STATE OF HAWAII
GEOTHERMAL ACTION PLAN

INDEPENDENT AIR AND NOISE PROGRAM REVIEW
CONCERNING THE JUNE 1991 UNCONTROLLED VENTING
OF
THE PUNA GEOTHERMAL VENTURES KS-8 GEOTHERMAL WELL

PREPARED BY: ROBERT L. REYNOLDS, APCO & NCO
LAKE COUNTY AIR QUALITY MANAGEMENT DISTRICT
883 LAKEPORT BLVD.
LAKEPORT, CA 95453

DATE: JULY 22, 1991

FIGURE 2

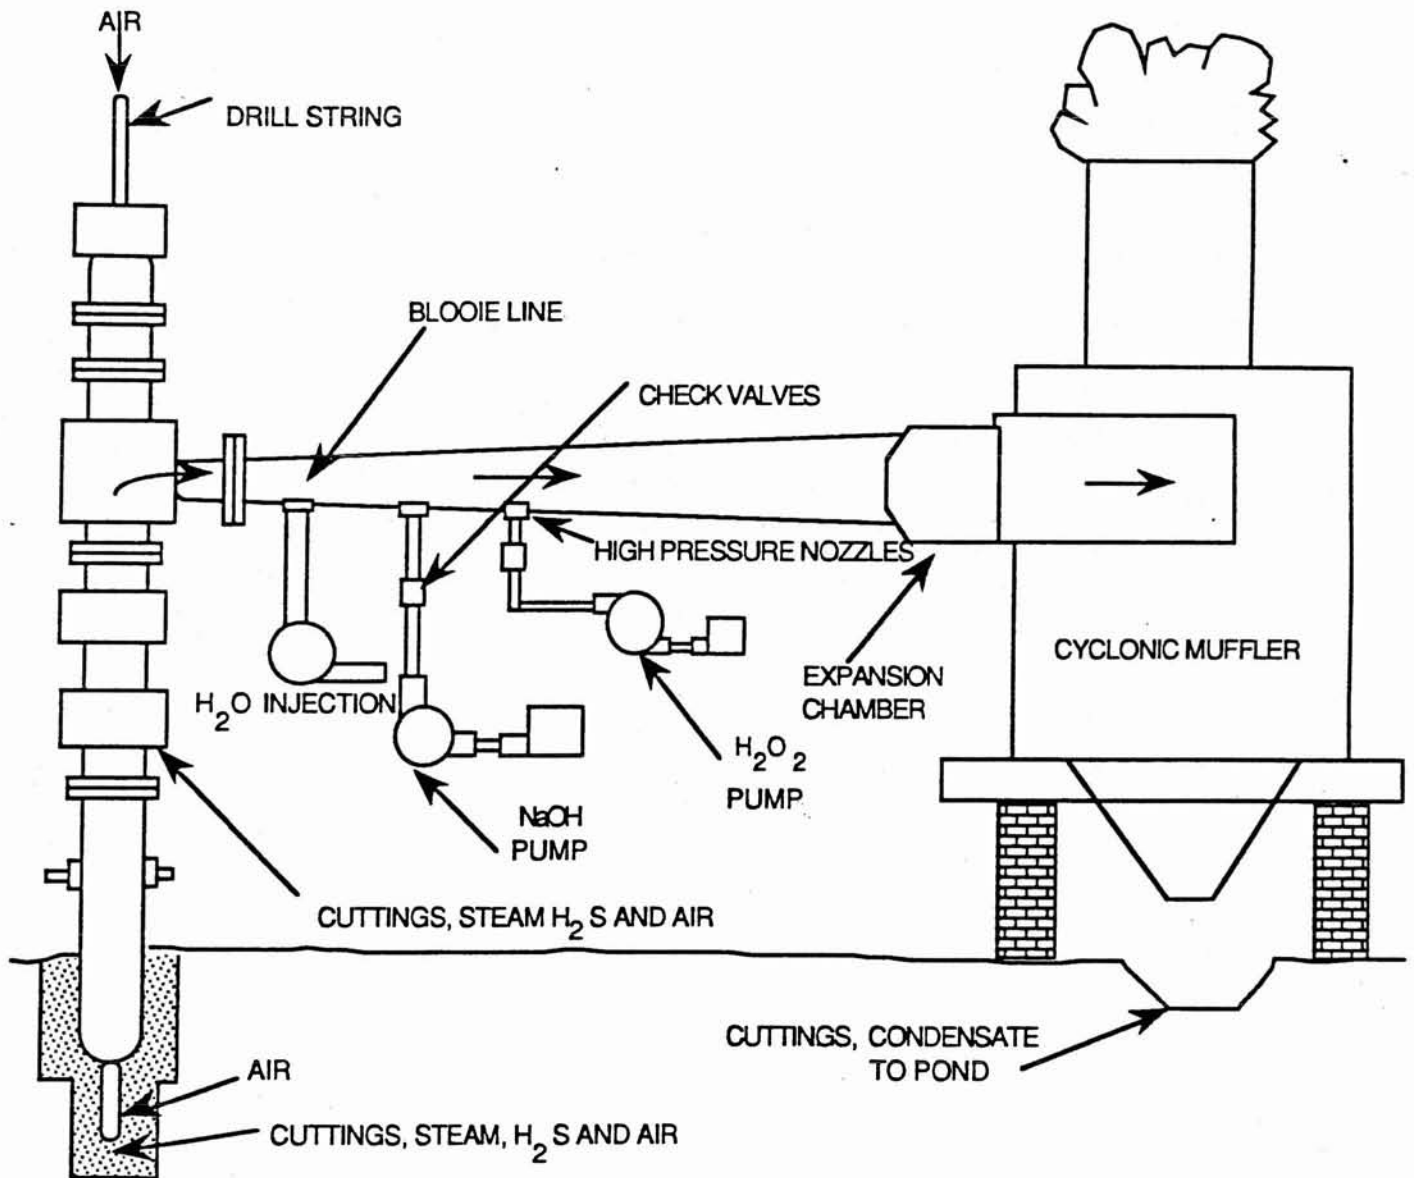
pressure relieve valves, H₂S abatement capability, wet cyclones for particulate removal and noise mitigation, and possibly even a large capacity muffler or stack. A typical system is shown in Figure 2, which also utilizes hydrogen peroxide to oxidize and stabilize H₂S. These need to have the capability of being promptly or automatically activated. The system should have an overcapacity, be directed in the best direction and sampling ports built in at appropriate locations to allow determination of emissions. Consideration of removing the ATC limitation on air drilling should also be evaluated if the developer believes that method to be safer, and perhaps more capable of controlled drilling. The practice of allowing short term uncontrolled venting (7 minutes, per ATC) needs to be evaluated as to possibility of appropriate concern for losing control of such venting and rather abatement is in place to mitigate.
